FIRE SAFETY INSPECTION REPORT

**ZOOM SWEATERS LTD.
PAITY ROAD, DERMA,1362, BANGLADESH**

March 3, 2014

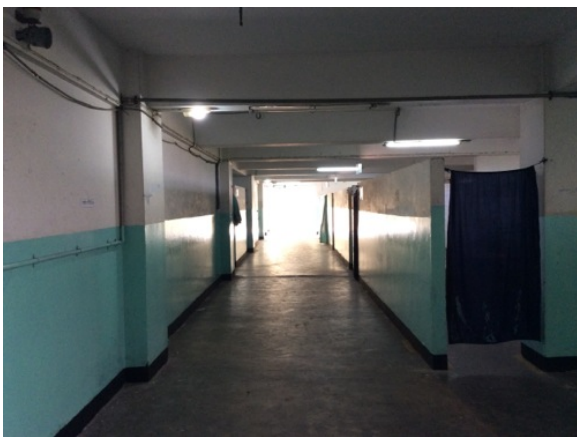
F-6	Egress	Collapsible gates and sliding doors are provided at exit stairs on each floor and at the west exit discharge.	Replace all gates / sliding doors along the means of egress with side-hinged, swinging egress doors.	Within 1 month
			If locks are required for security reasons, utilize special door locking features complying with NFPA 101.
